# **CONNECTION ASSESSMENT & APPROVAL PROCESS**

**Project: AVR Replacement for  
Kirkland Lake G1, G2 and G4**

**CAA ID: 2011-EX559**

## **IESO EXPEDITED SYSTEM IMPACT ASSESSMENT – 2011-EX559**

**Figure 1: Positive ceiling**

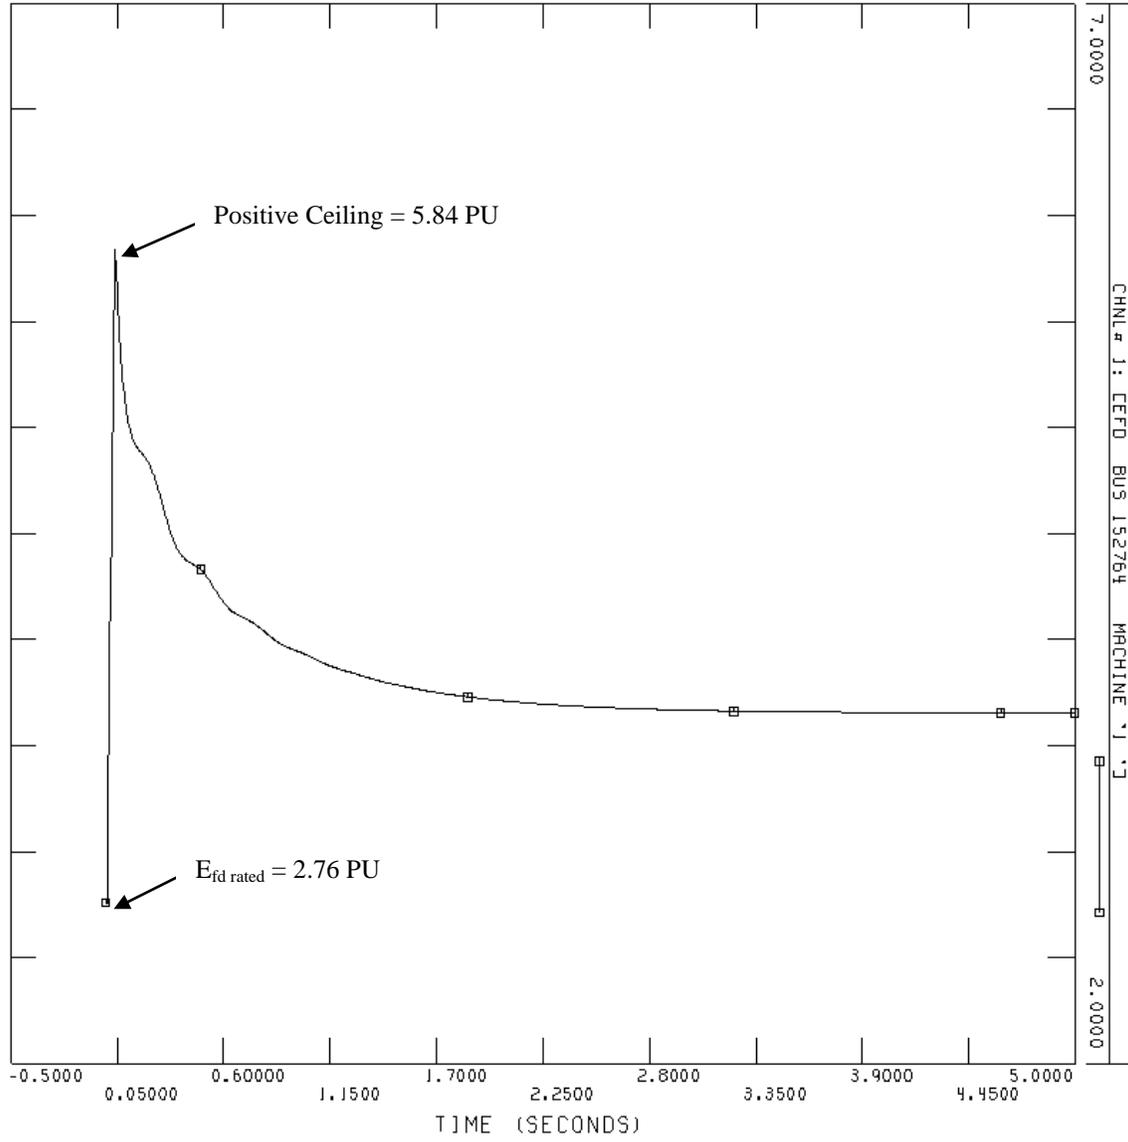
Response ratio test was performed to determine the positive ceiling limit for the excitation system. Market Rule requires that the excitation system should be able reach a positive ceiling of 200% of the  $E_{fd \text{ rated}}$ .

$$\text{Required Positive ceiling} = 2 \times E_{fd \text{ rated}} = 2 \times 2.76 = 5.52 \text{ p.u}$$

$$\text{Exciter positive ceiling response} = 5.84 \text{ p.u}$$

Simulations show that the excitation system positive ceiling response meets the Market rule requirement.

**Figure 2: Negative ceiling**

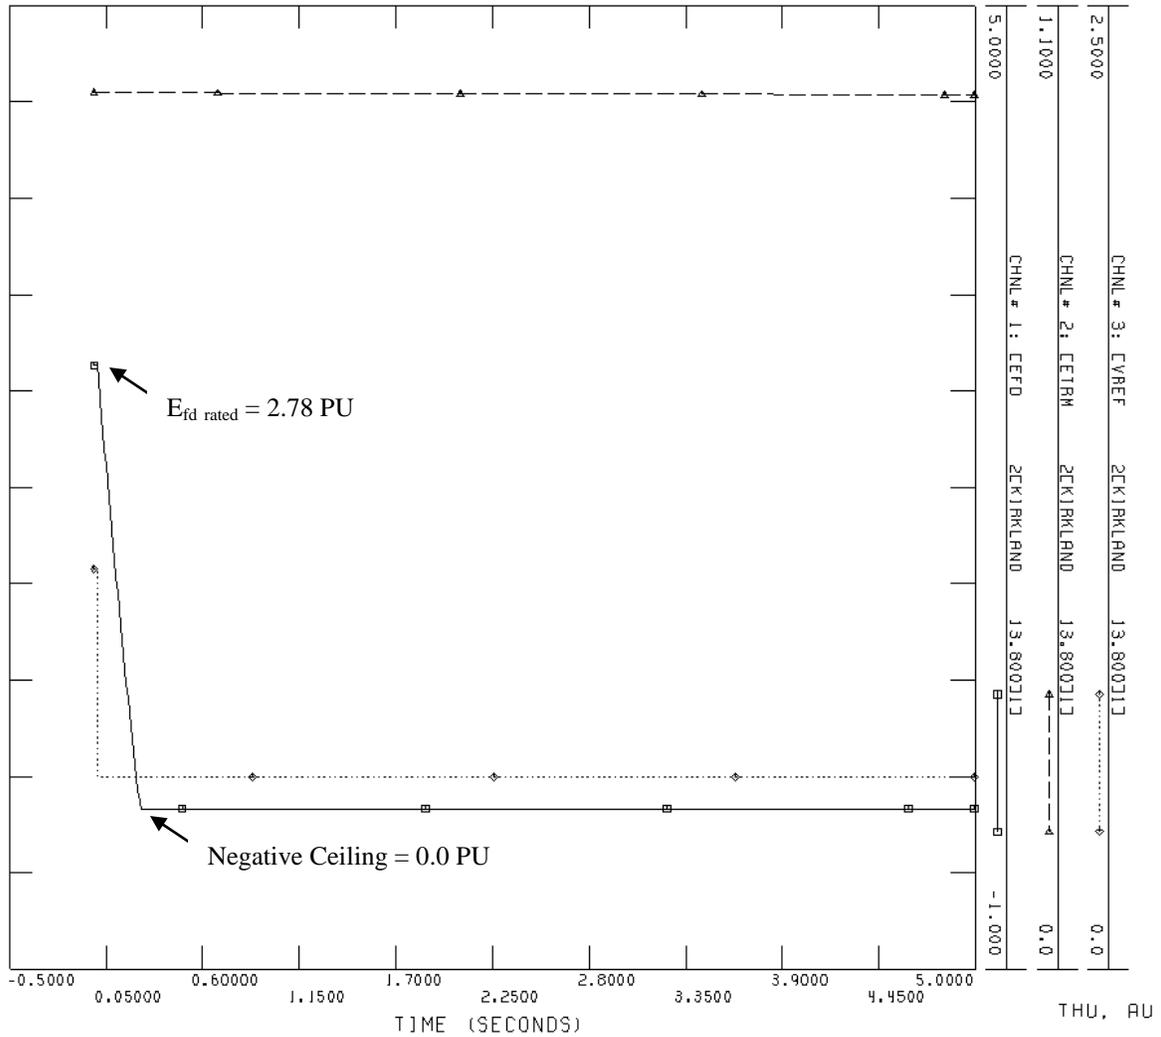
Market rules stipulate that excitation system for the synchronous generators should be able provide a negative ceiling of 140% of the  $E_{fd \text{ rated}}$ .

Required negative ceiling =  $-(E_{fd \text{ rated}} \times 1.4) = -(2.76 \times 1.4) = -3.864 \text{ p.u}$

Exciter negative ceiling response = 0.0 p.u

**Figure 3: Positive ceiling voltage response time**

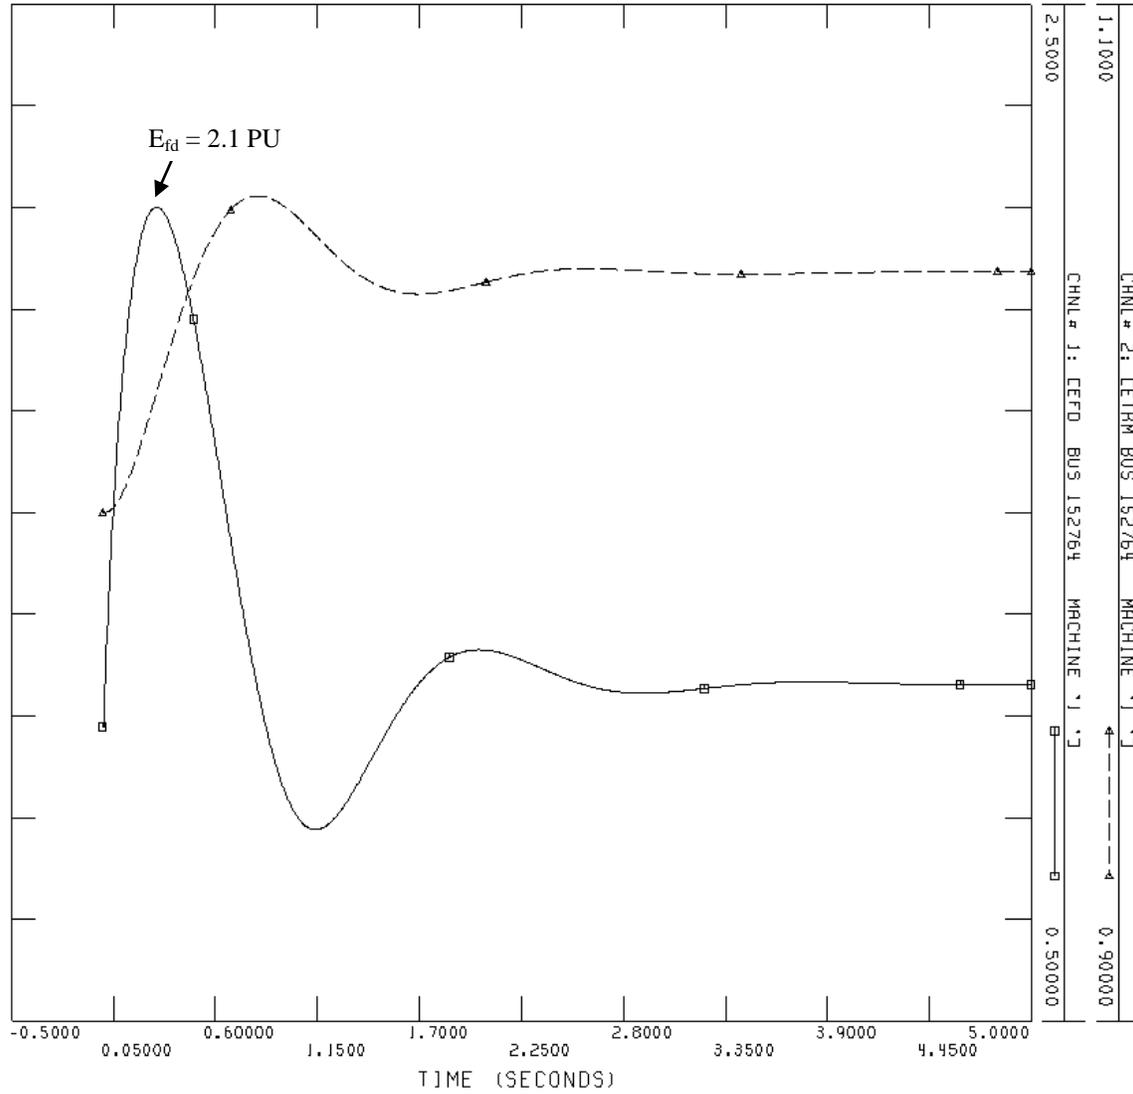
For positive ceiling a reference voltage step change of 5% was simulated to verify that the excitation system is capable of reaching  $1.95 \times E_{fd \text{ rated}}$  within 50 ms.

$$RT_{OC\_POS} = 82.07 \text{ ms}$$

$$\text{Required } E_{fd} \text{ (positive) ceiling} = 1.95 \times E_{fd \text{ rated}} = 1.95 \times 2.76 = 5.382 \text{ p.u within } 82.07 \text{ ms}$$

Plot for open circuit test (Figure 3) shows that excitation system reaches the  $E_{fd}$  of 2.1 p.u in 25.2 milliseconds for a voltage reference step change of +5 %.

**Figure 4: Negative ceiling voltage response time**

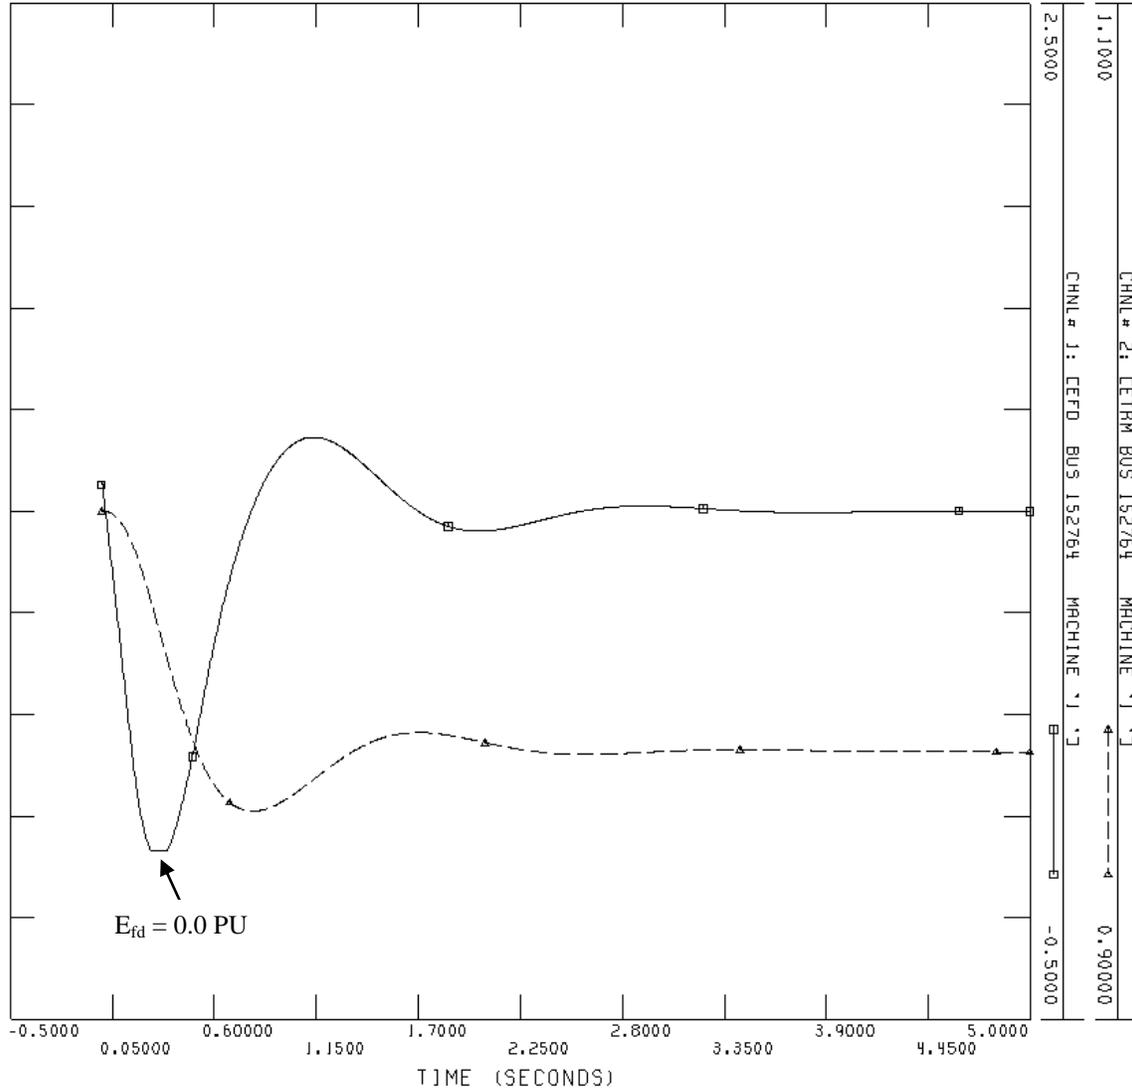
Starting from  $E_{fd \text{ rated}}$ , the excitation system should be able to reach a negative ceiling of 128% within 50 ms for a voltage reference step change of -5%. Test results are translated to open circuit voltage response time by using the equation given below.

$$\text{Required } E_{fd} \text{ (negative) ceiling} = -1.28 \times E_{fd \text{ rated}} = -3.53 \text{ p.u}$$

$$RT_{OC\_NEG} = 36.70 \text{ ms}$$

Figure 4 depicts that excitation system reaches a negative ceiling of 0.0 p.u in 25.7 mili seconds for voltage reference step change of -5%.
